Oregon State University

RESER STADIUM WESTSIDE COMPLETION FOOD SERVICE EQUIPMENT

ADDENDUM NO. TWO (2)

ISSUE DATE: June 13, 2022

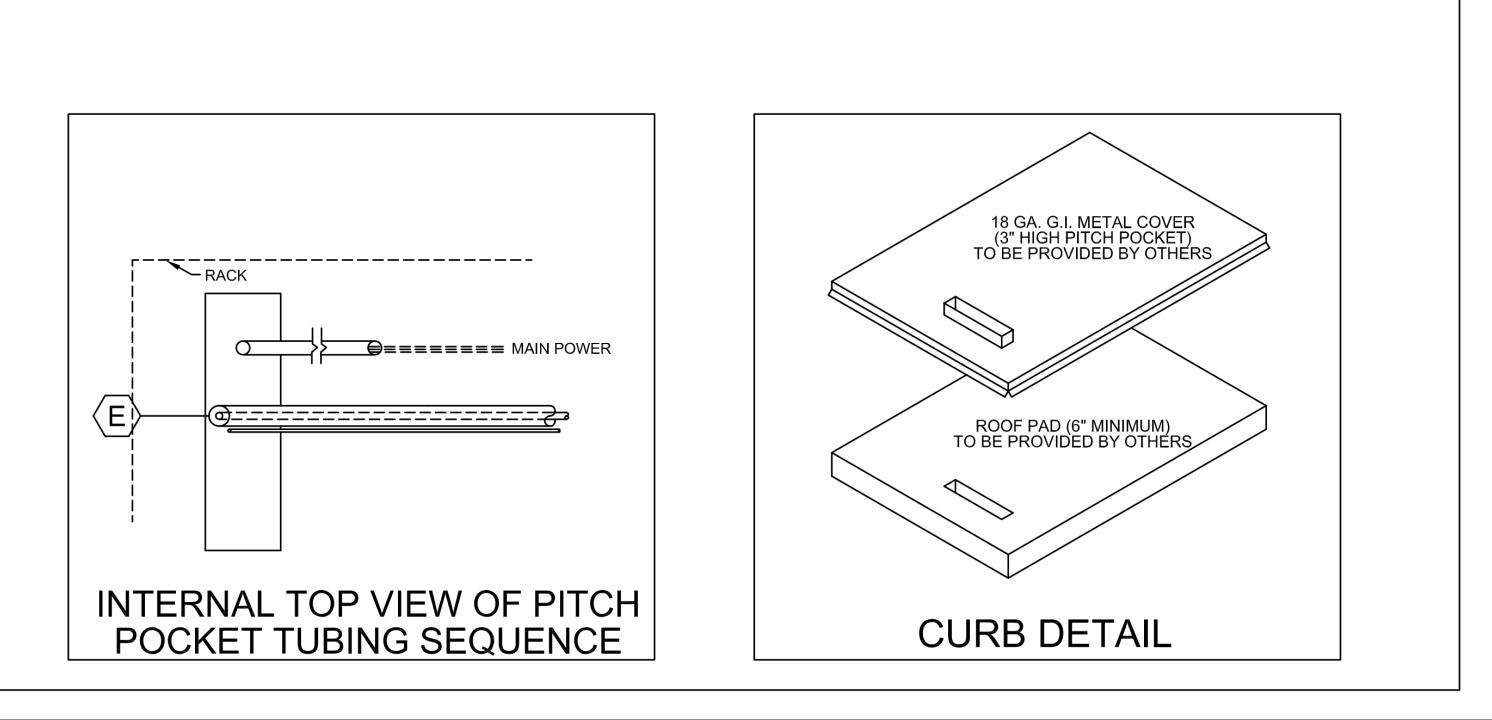
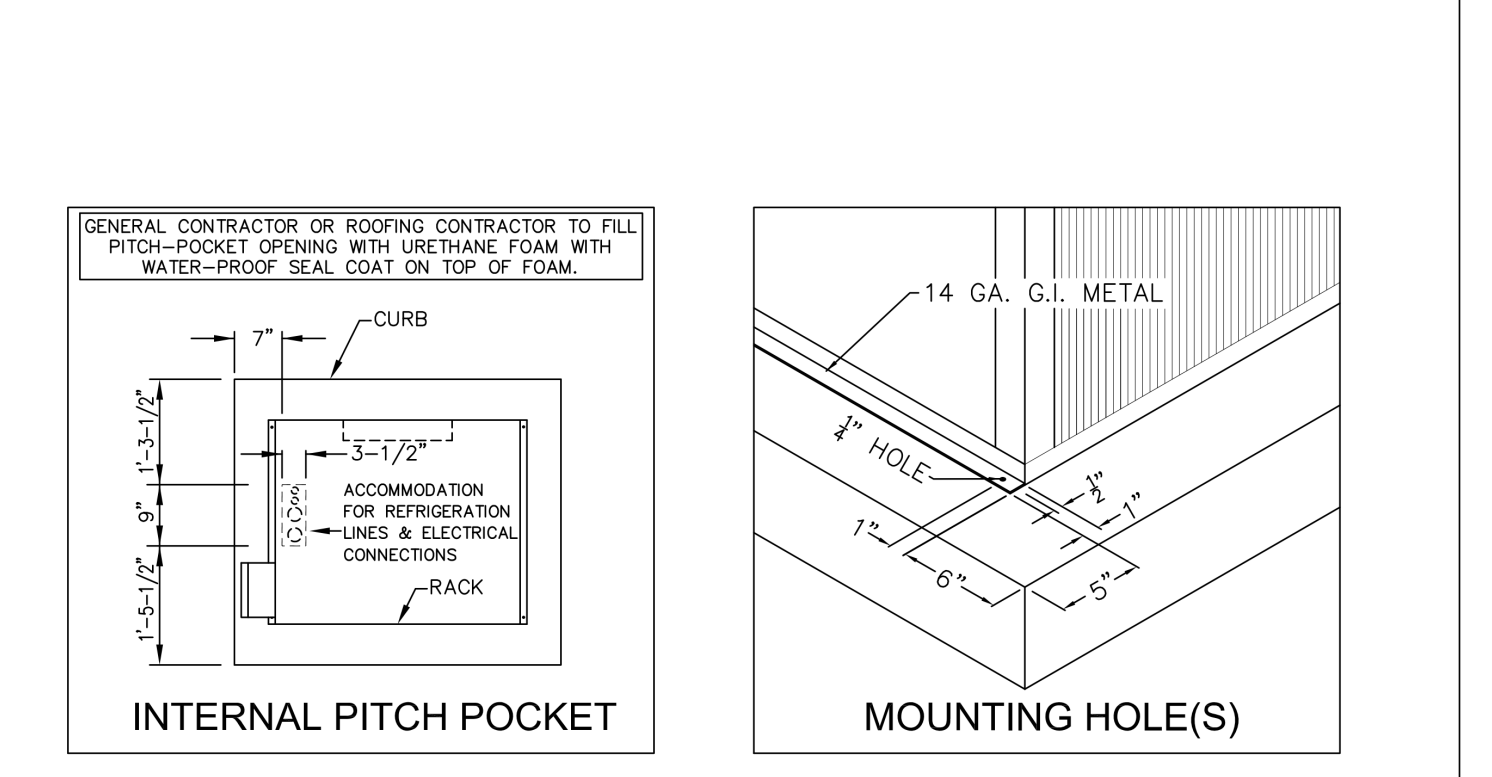
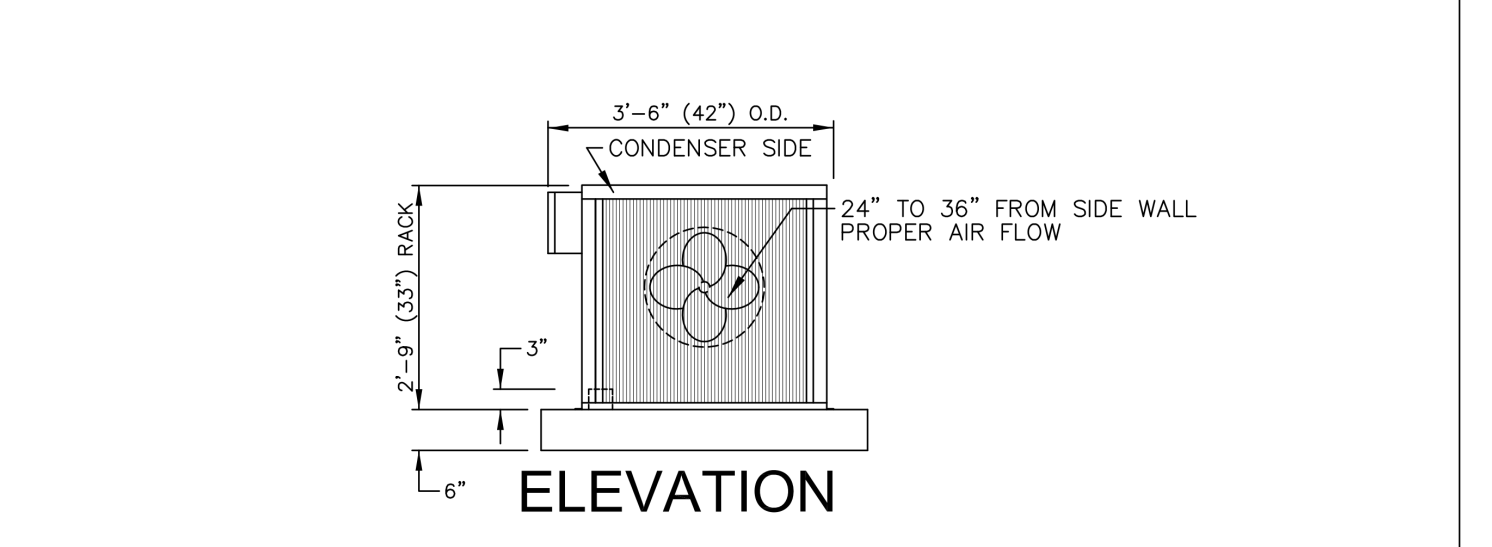
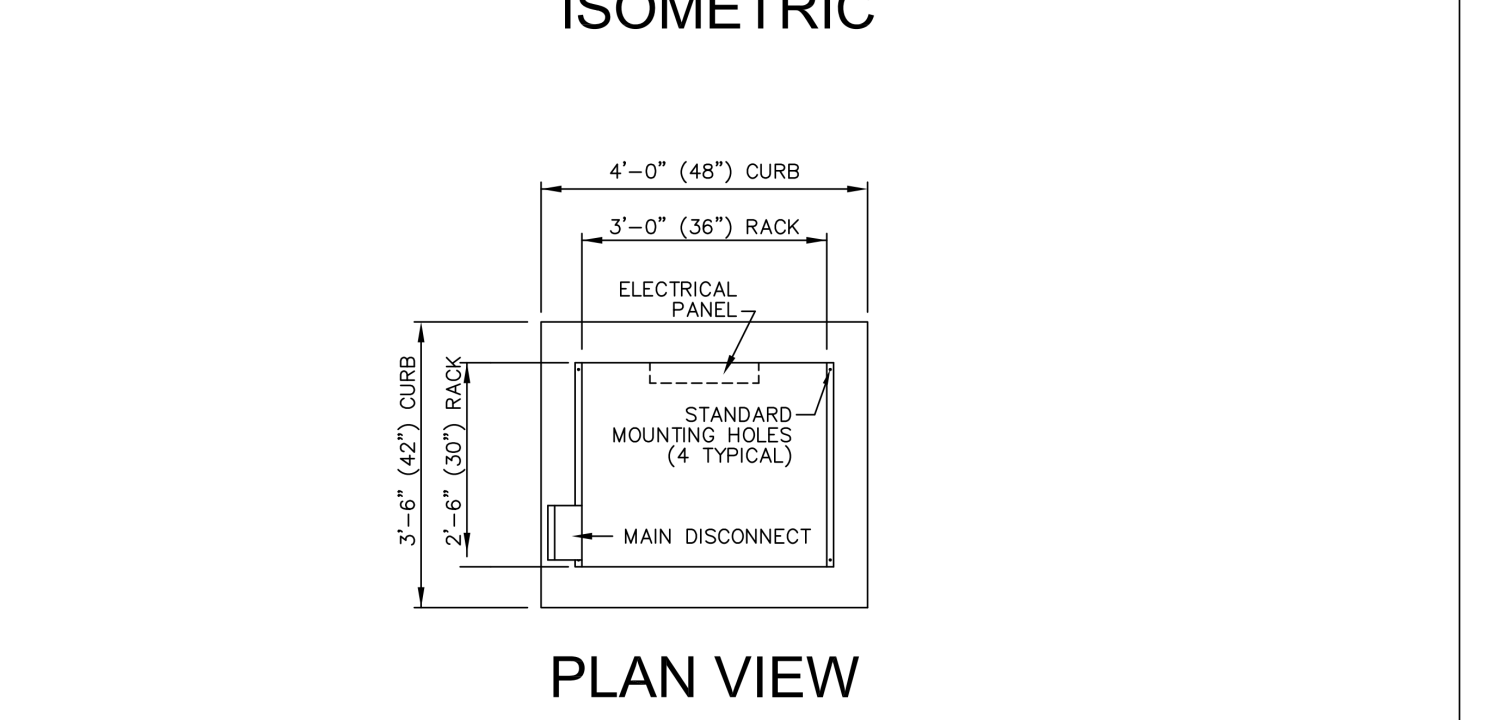
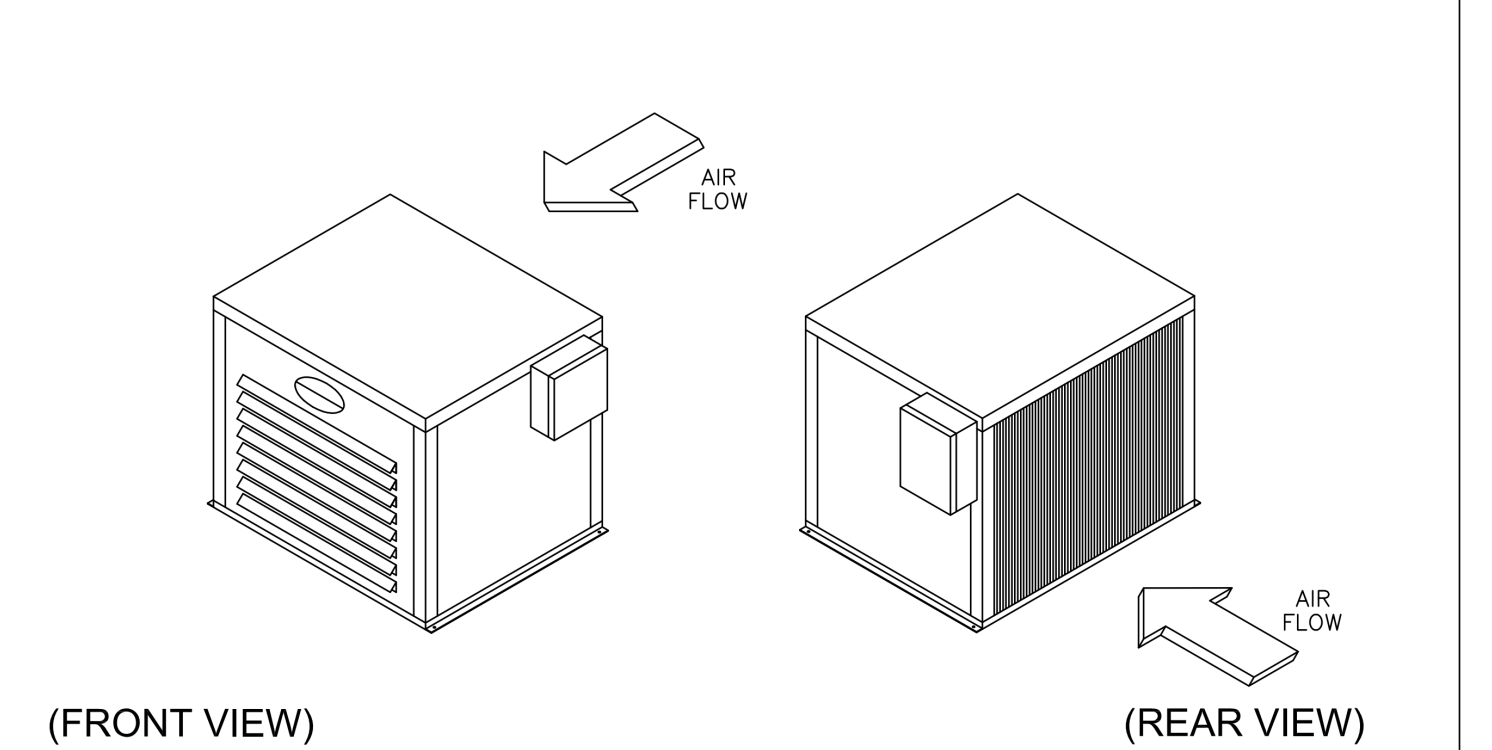
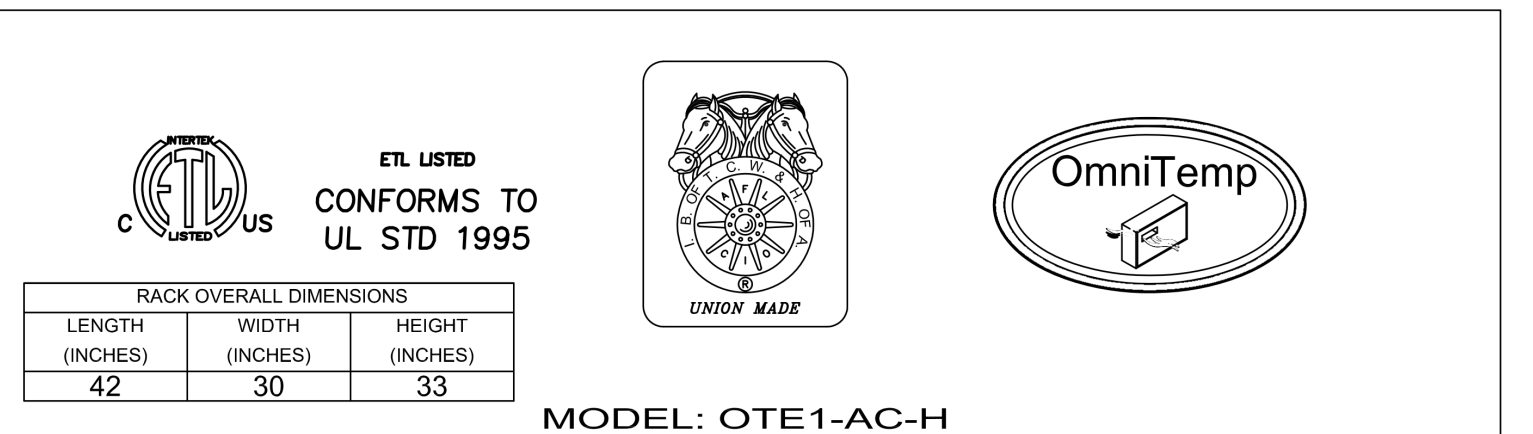
Item 3 Q: Regarding Addendum 1: Item # 7 & #26, references plan sheet QF700-4 & QF700-5.

Although QF700-4 & QF700-5 drawings are referenced on the plan index page AF011, these two drawings are not included in the downloaded plans?

A: The two drawings are included with this addendum.
